**Our Case Number:** ABP-314597-22

**Re:** BusConnects Galway Cross-City Link Scheme.  
University Road to Dublin Road, Galway City.

Case reference: HA61.314597 University Road to Dublin Road, Galway City.

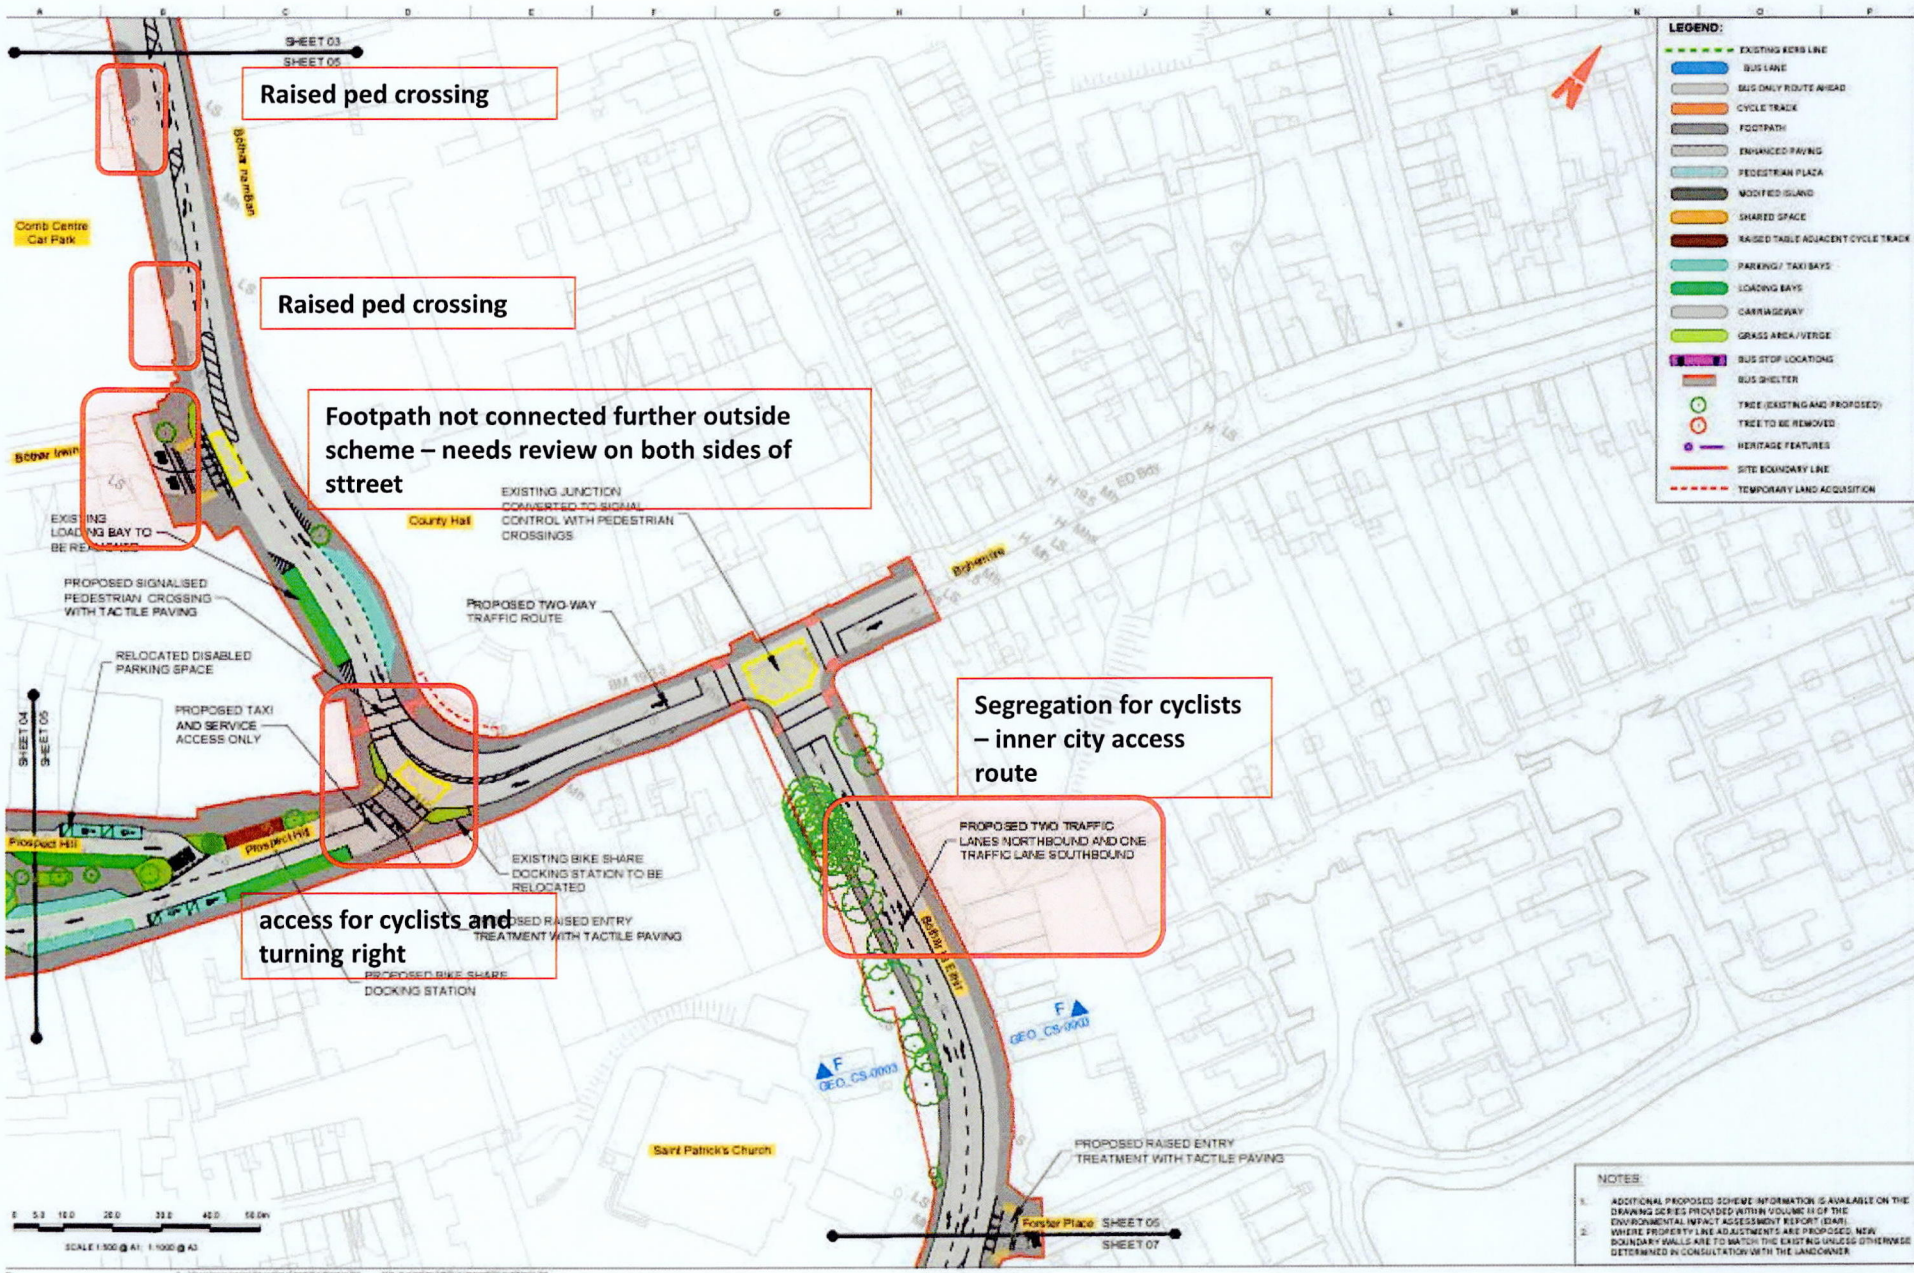
**Increase cycle parking**

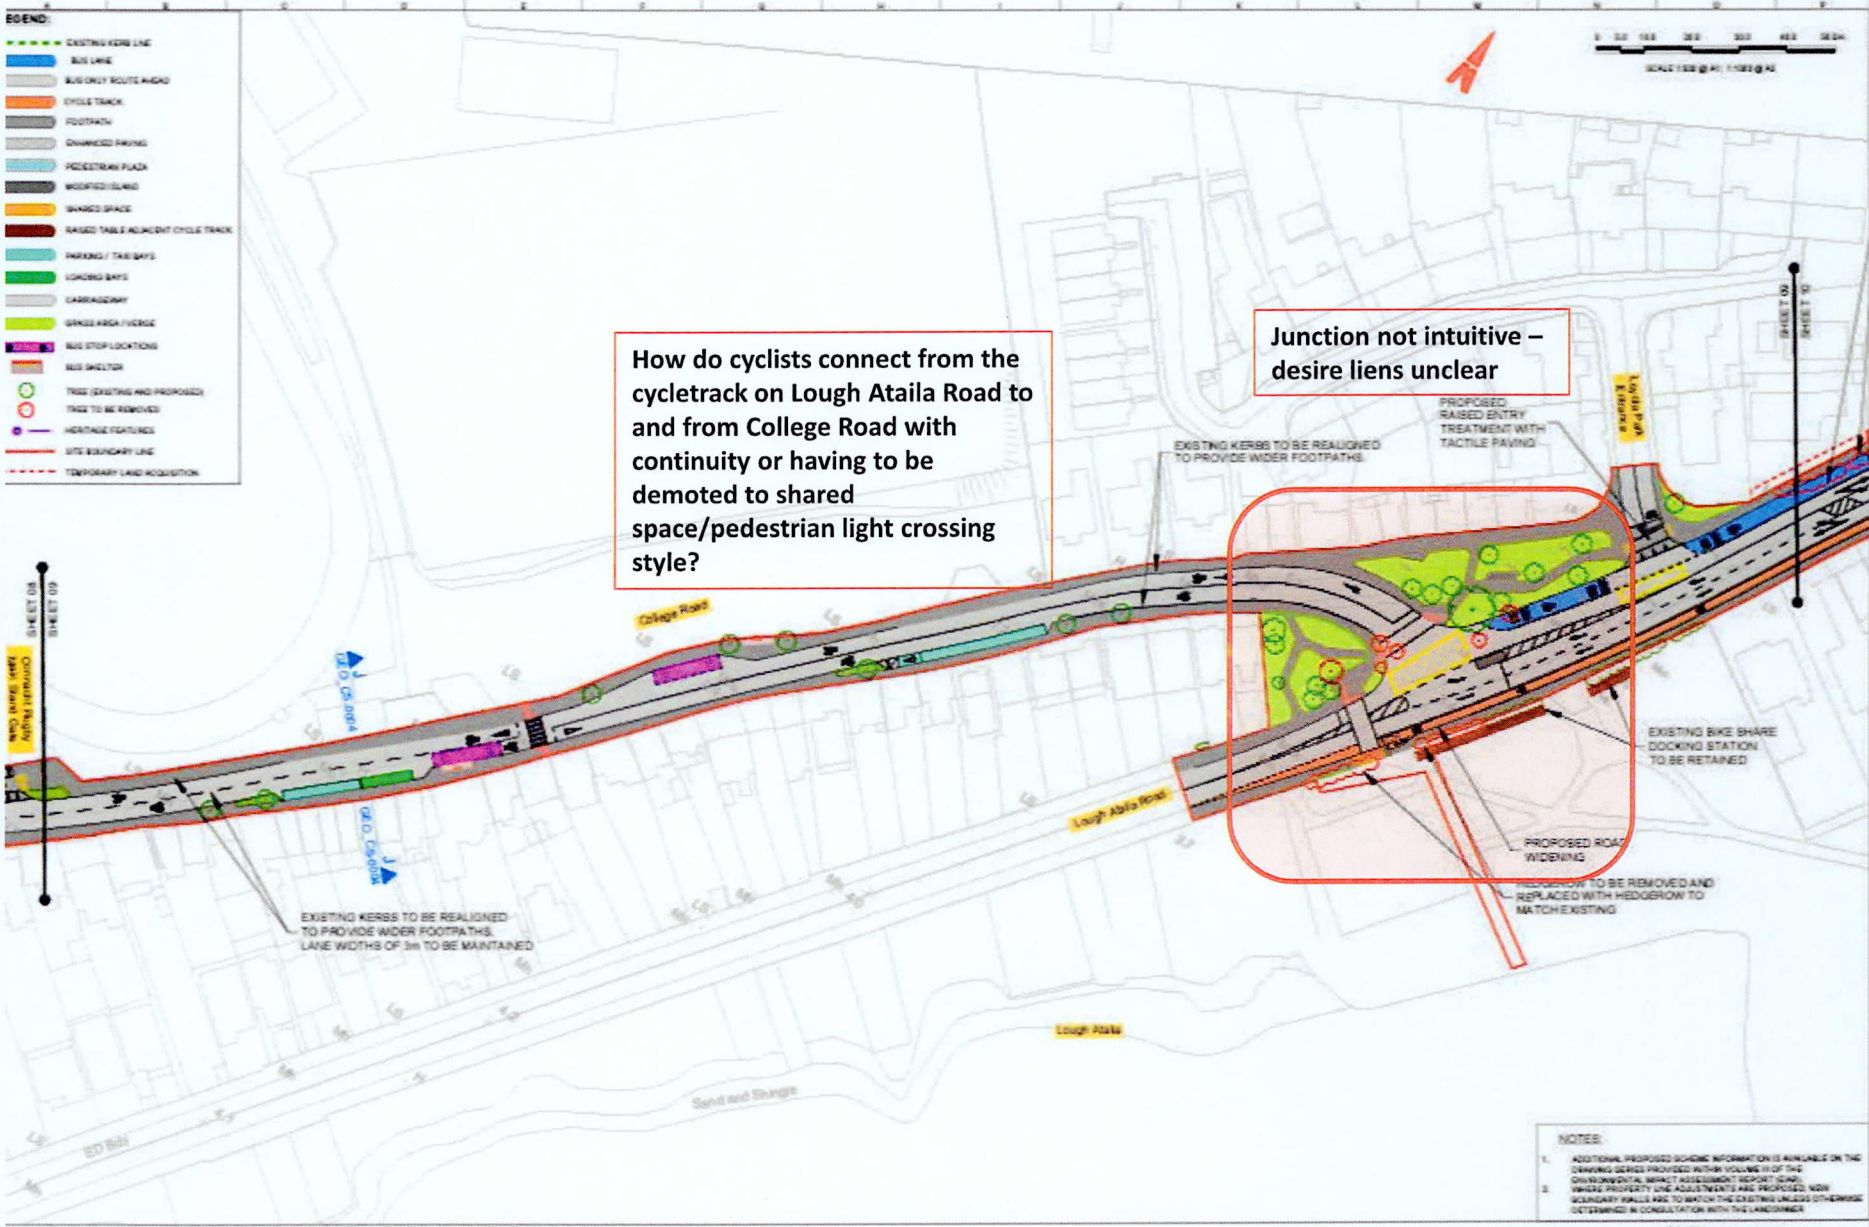
How do cyclists connect from the cycletrack on Lough Ataila Road to and from College Road with continuity or having to be demoted to shared space/pedestrian light crossing style?

Junction not intuitive – desire liens unclear

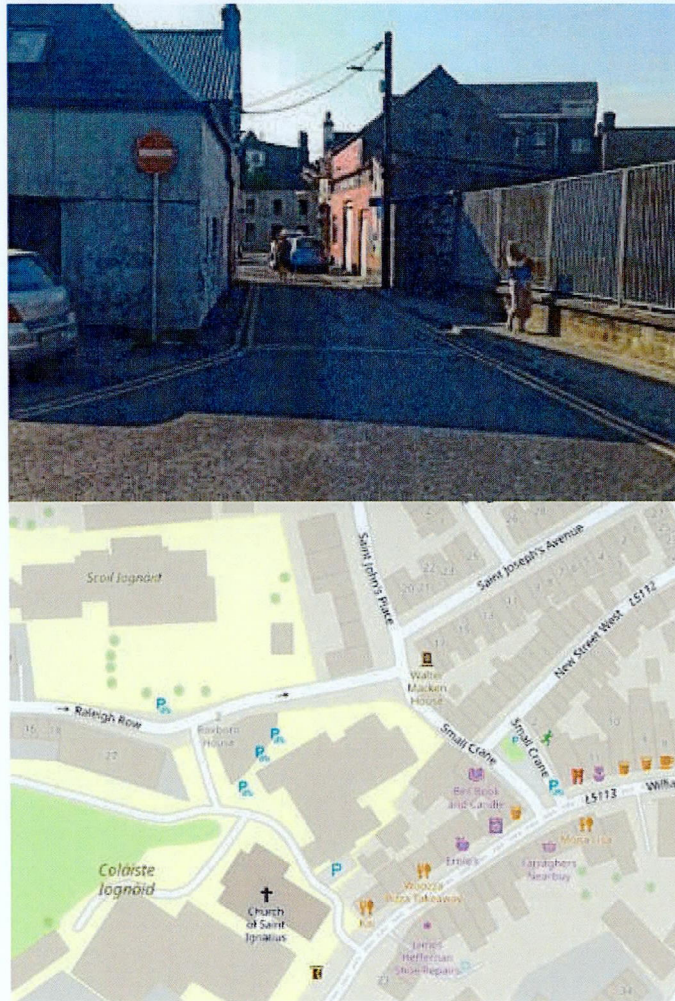
One impact of the proposed scheme is that applicants will apparently ban cycling south on Newtownsmith. This is confirmed in my reading of their response. The Galway Educate Together Secondary School recently relocated to Newtownsmith and the apparent effect of the design will be to require cycle-traffic, including secondary students, to make a 2.4km detour to reach that location from the east. This is reviewed in more detail below but the wider context is an established pattern of actions by the applicants that make cycling access by schoolchildren in the city more difficult and inconvenient. See photos below.

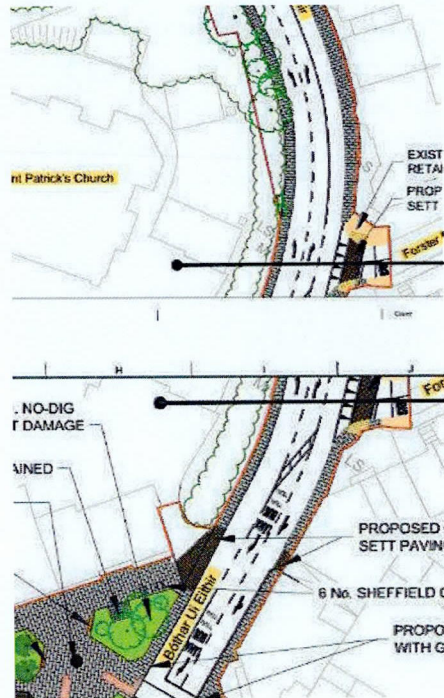
Along most of the west side Bóthar Ui Eithir the scheme drawings show a 4.5m verge. Taking the verge into account there is 20m width available within the corridor. There is a pinch point at the southern end of the road where the grounds of St Patricks church run along the boundary (the width here is 13.5m) however the lands inside the boundary are green space. The scheme "Landscape General Arrangement" drawings show this part of the church grounds as "retained vegetation". It seems to me it could be possible to CPO enough width without impacting any of the buildings within the church grounds. Just south of the entrance to the church grounds there is another pinch point at the corner of the building that currently houses the driver (theory) testing centre. At this point in the road the width between building curtilages is 16.7m. The drawings show a short length of bus lane marked here for buses turning right into Forster St. Within this 16.7m there is still scope for giving cyclists space by providing 2 x 2m footpaths 2 x 4.8m traffic lanes and a 3m central bus lane.

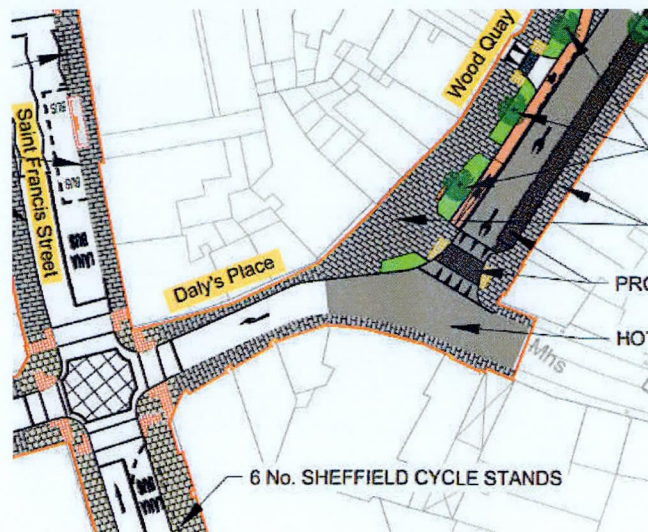
As noted above, previous Irish and UK guidance, and the current Irish Traffic Regulations provide for contra-flow cycling arrangements without segregation at traffic speeds of 30km/h or less and traffic volumes of less than 1,000 vehicles per day. Daly's Place, St Anthony's Place and Court Lane are to be in the new 30km/h city centre speed limit zone. The in EAIAR Vol 2 Chapter 6 the traffic forecasts state that traffic volumes using Daly's Place are expected to fall by 100% in both the AM and PM peaks. The traffic forecasts show zero traffic using Daly's Place at those times. This would seem to put Daly's place below long understood thresholds for allowing unsegregated contraflow cycling. I would also note that any traffic trying to reach Daly's Place from Wood Quay first has to pass over a speed ramp/entry treatment shown in the drawings. As noted above, current UK guidance allows for unsegregated contraflow cycling at lane widths as low as 2.6m. By my measurements the narrowest point in Daly's Place is 6.4m. If 1.8m footpaths were used that would leave 2.8m for a traffic lane. Alternatively if effectively zero motor vehicles are expected to use Daly's place then perhaps it could simply be refactored as a mini shared space or plaza with a raised table entry-treatment at footpath height. If a raised entry treatments are already proposed for the southern end of Wood Quay and also St Anthony's Place then why not also within Daly's Place?

**Dyke Road**

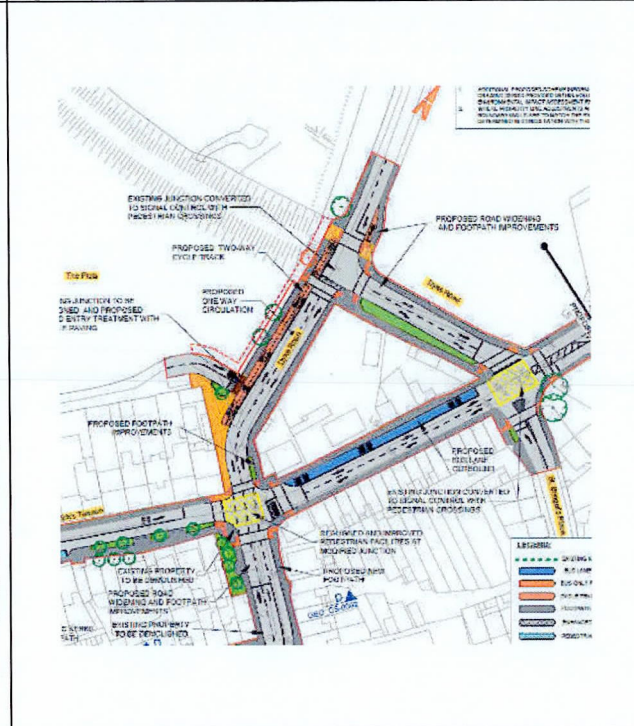
Space to wait for cyclists to turn right toward the Plots from the Dyke Road, (inbound) adjacent to the Dyke Road Carpark, is too small. There does not seem to be enough space for several bikes to wait it traffic is moving forward from behind. Considering families often use the dyke road or groups of children, young cyclists or cargo bike users need to turn. More space to wait safely and turn is needed. Turns around some of the junctions onto and off of cyclelanes/road crossings are very tight for some cargo bikes to safely make a turn. With a few cyclist or cargo bikes and cyclist mixing with pedestrians waiting to turn or cross. It is not ideal. More space for circulation is needed at these junctions for cyclist and pedestrian to avoid conflicts.

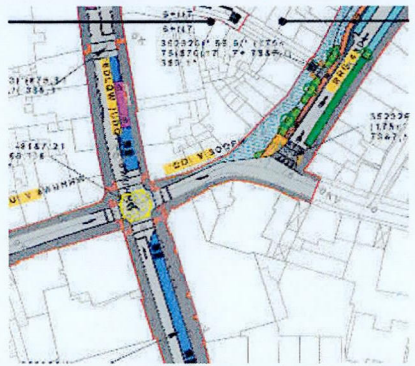
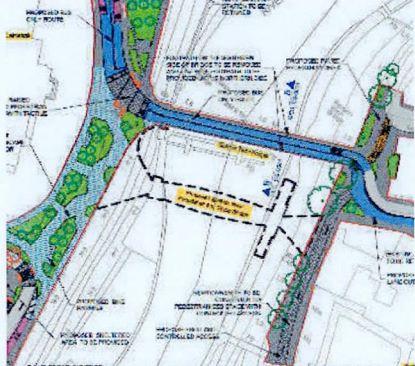
Cyclist exit from cycleway to cross Headford road and turn right or left should be improved. Suggest to allow for cyclelane to come to the head for Woodquay side road. Doing this will allow for confident cyclists to avoid having to cycle on a shared footpath space at a junction where there are two areas at the corner where pedestrians will be waiting to cross. It is unnecessary to force all cyclist onto the path as the road into woodquay side road is one-way (inbound) for traffic.

There is space to bring the cycle track on the side road to meet the main Headford road.
